PLANNING COMMISSION  
DATE: 05/22/2017  
AGENDA ITEM: 4A– PUBLIC HEARING ITEM  
CASE # 2017-20

**TO:** Planning Commission  
**FROM:** Stephen Wensman, Planning Director  
**AGENDA ITEM:** Parcel A – Schiltgen property Concept PUD  
**REVIEWED BY:** Stephen Wensman, Planning Director  
Emily Becker, City Planner  
Jack Griffin, City Engineer  
Ann Pung-Terwedo, Senior Planner, Washington County

Re: Gonyea Village West (Shiltgen Parcel A)  
Concept Plan Review

**PUD CONCEPT PLAN**

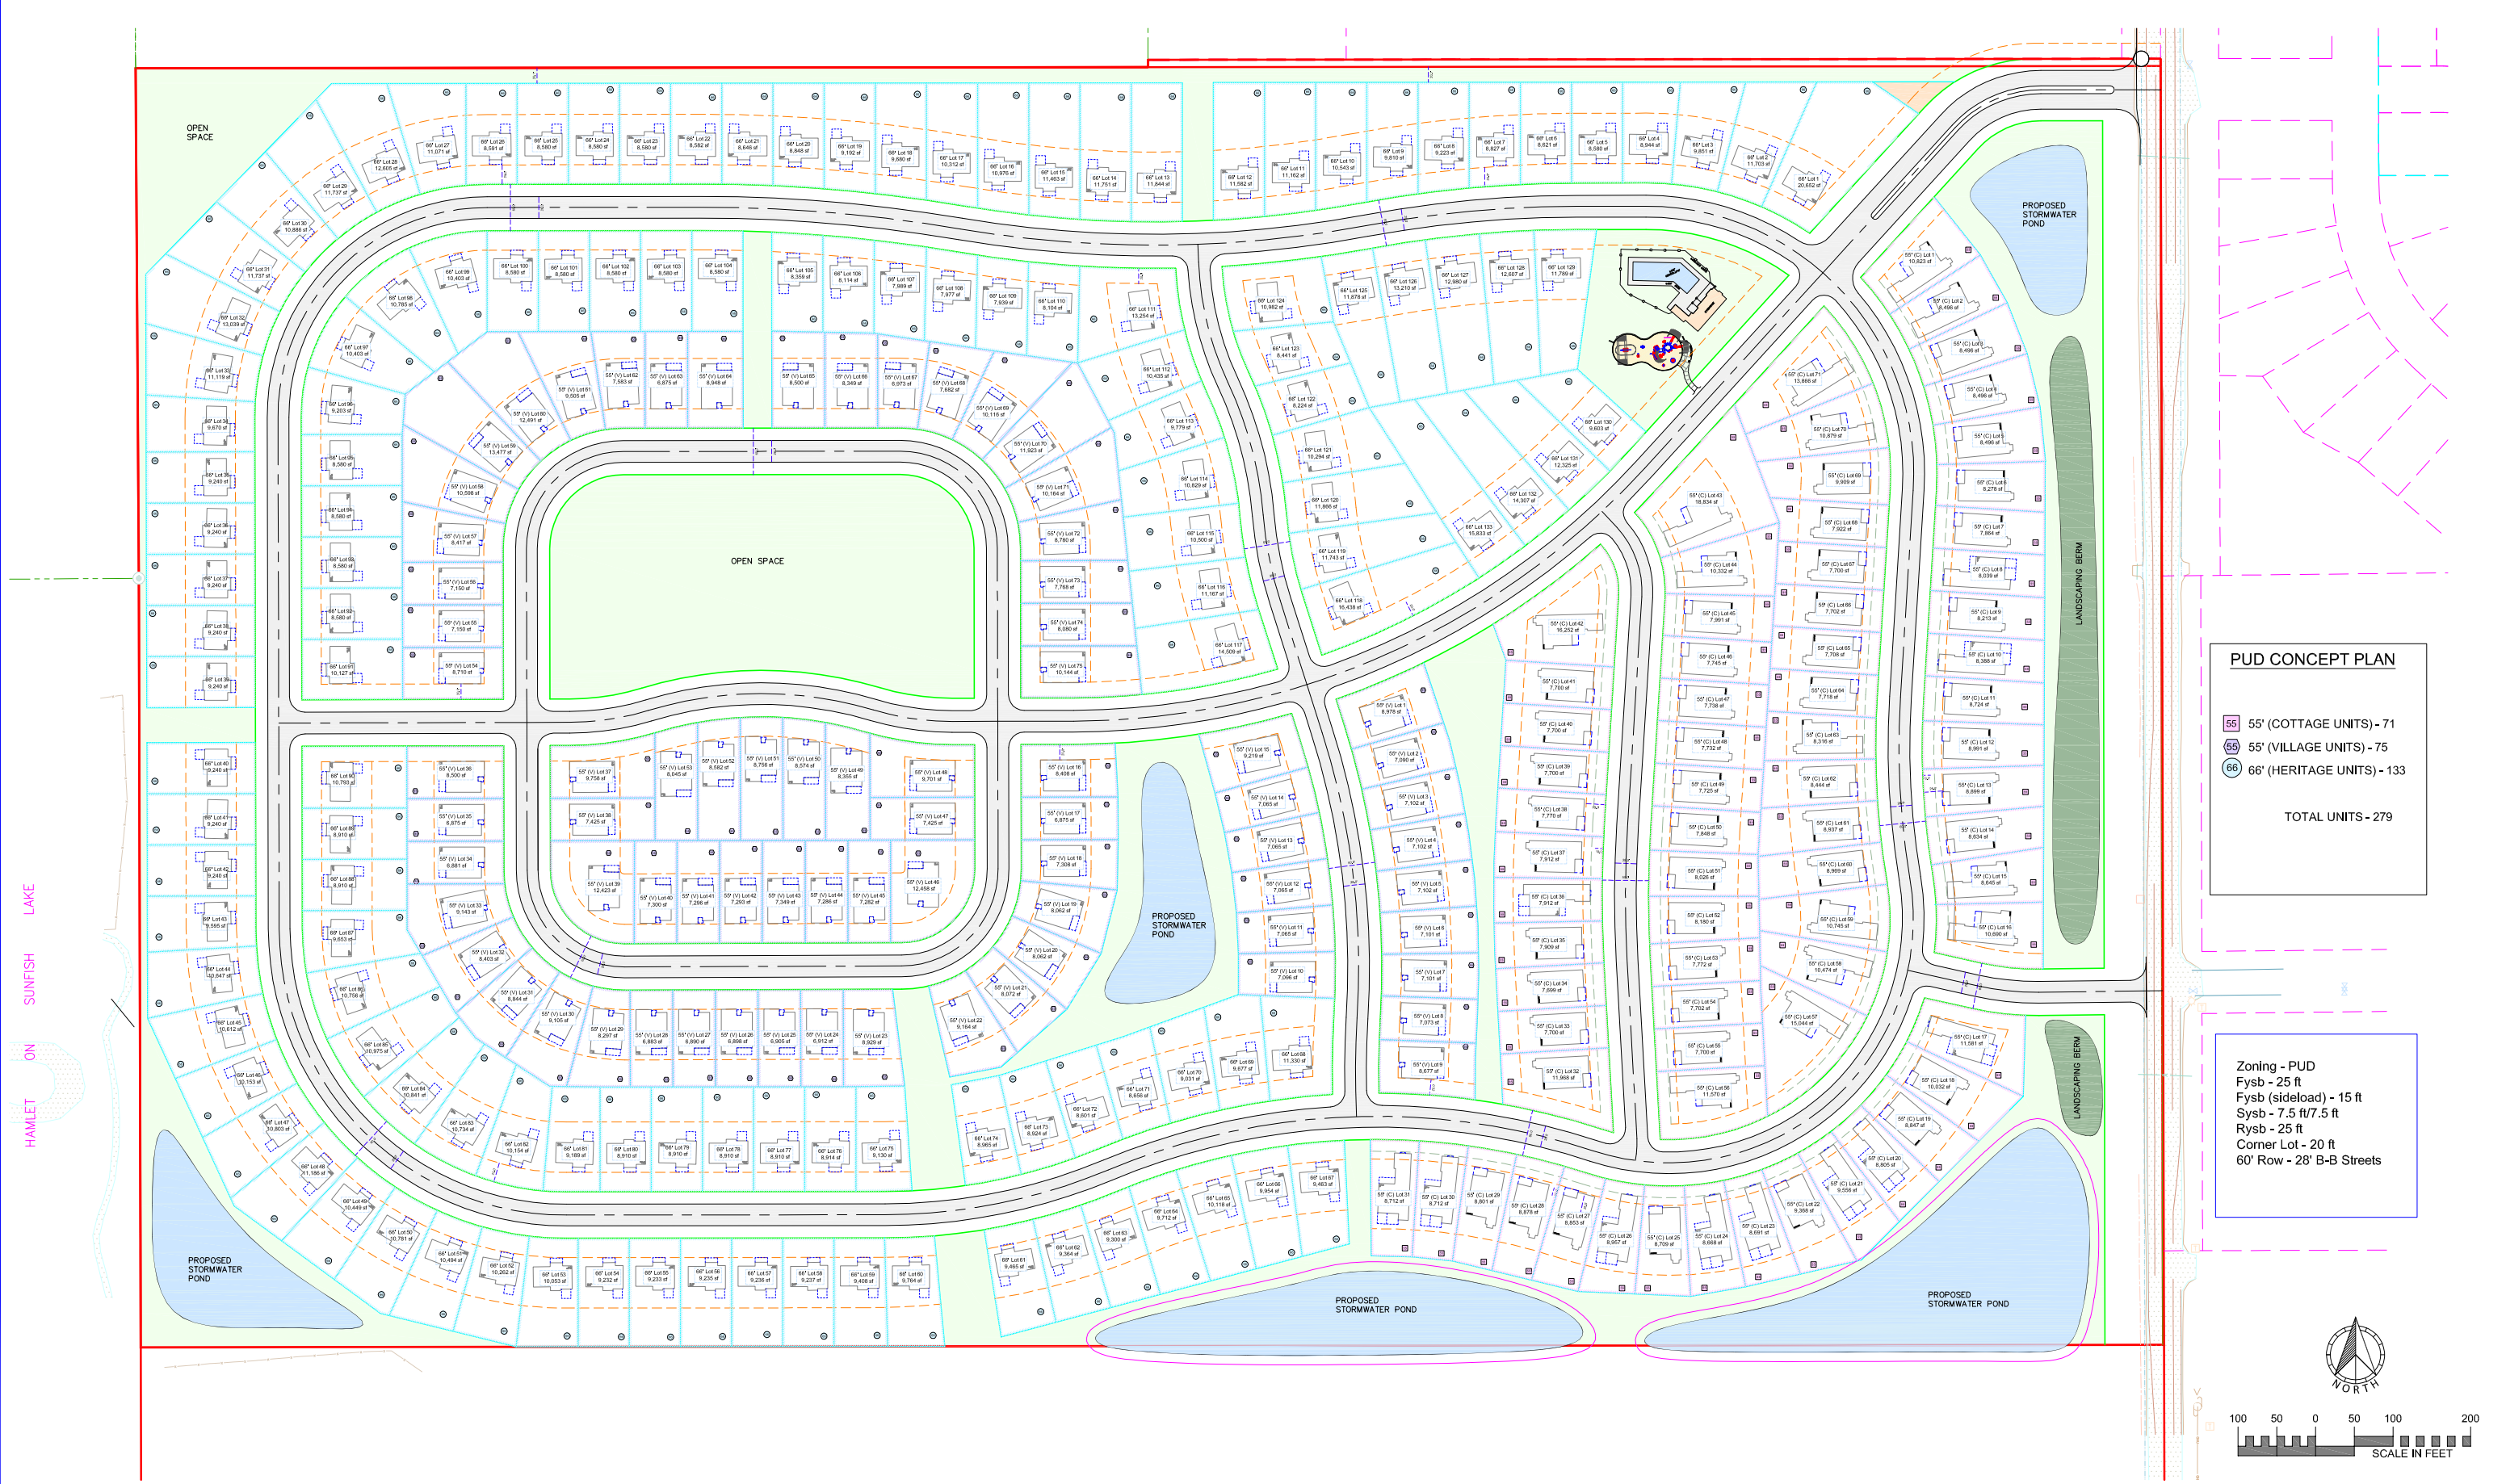
- c. Street Layout: The PUD ordinance appears to place a preference for a street grid to compliment the older portions of the City. The proposed PUD development does incorporate a modified street grid, but does not include street stubs to the north or south where future subdivision may occur.

**Sidewalks.** The City's standard street detail requires a 6 foot wide public sidewalk be constructed on one side of any public street and to accommodate a sidewalk, the standard right-of-way width is 60 feet wide. The developer has not shown sidewalks on any streets.

Although the overlay in the Comprehensive Plan is not dimensioned, it appears as though the width of the overlay is around 200 feet. The buffer shown in the proposed development is 20' on the north edge and 10' on the west edge. It is Staff's recommendation that the buffer areas be enlarged such that they are more easily maintained and do not become a dumping area for leaf litter, sticks, or other debris, or are incorporated into the surrounding lot area with significant berming, landscaping and a landscape easement as required by the V-LDR Zoning Code and protected by an easement such that individual homeowners cannot remove the required landscaping. This has been an issue in other developments where required landscaping is later removed by homeowners to make room for private amenities or simply because they do not like the landscaping.

**HOA recreation area parking.** The proposed pool and playground near the north entrance drive is in a prominent location that will make for an attractive entrance to the development. With 28' wide streets, parking will be allowed on both sides of the street, but the parking will potentially create significant congestion. The Commission may want to consider the parking for the recreation area and may want to require a dedicated parking area for it.

- Right-of-way dedication. The Plat must dedicate sufficient right-of-way along CSAH 17 (Lake Elmo Avenue) as required by Washington County. The concept plan shows this dedication, however the actual right-of-way widths must be reviewed and approved by the County.

- Access Management. The Concept plan shows two access locations to Lake Elmo Avenue, one at 39th Street North and one at 41st Street North, approximately 1,160 feet apart. Both locations have been previously determined by the City and Washington County and should be acceptable access locations for the development.

- The proposed internal street network is well interconnected creating multiple access routes into and out of the development.
- Right-of-way and street stubs should be constructed as part of this development to plan for connectivity to adjacent properties to the north and south. The north right-of-way and street stub should be located to allow the northerly property to plat a 2-sided street as part of any future development of that site. Two separate right-of-way and street stubs should be planned to connect to the southerly property.

- Parkway or divided roadways must be a minimum of 19 feet wide from face of curb to face of curb. The development street plan indicates landscaped medians at the 41st Street development entrance.

- As part of the PUD application the development is proposing front yard setbacks as little as 15 feet. Reduced front yard setbacks should only be considered after receiving detailed right-of-way/utility easement design layouts demonstrating that all infrastructure is being adequately accommodated. For example, with a 15 foot front yard setback and a 10 foot utility easement corridor, the homeowner has only 5 feet between the easement and garage/home to plant front yard trees.

- It appears that all storm water facilities (ponds and infiltration basins) have been placed in Outlots. These Outlots will be deeded to the City for maintenance purposes. The Stormwater Facility Outlots must fully incorporate the 100-year HWL, 10 foot maintenance bench and all maintenance access roads. The Concept plan shows the 100-year HWL encroaching onto the adjacent property to the south. The storm water ponds will need to be moved north to contain them within the development site.

10. That the developer provide trails as recommended by the Parks Commission.
11. That any approval be contingent on complying with Washington County's requirements and requests pertaining to right-of-way, turn lanes and trail needs.

12. That the preliminary plat and preliminary PUD Plans submittal include a landscape and buffering plan to address open space overlay area requirements.

17. That the preliminary plat and preliminary PUD Plans submittal include a parking area for the HOA pool/playground recreation area.
18. That the preliminary plat and preliminary PUD Plans submittal include a detailed architectural plan and clearly identify the various architecture styles and locations for them on the plans.
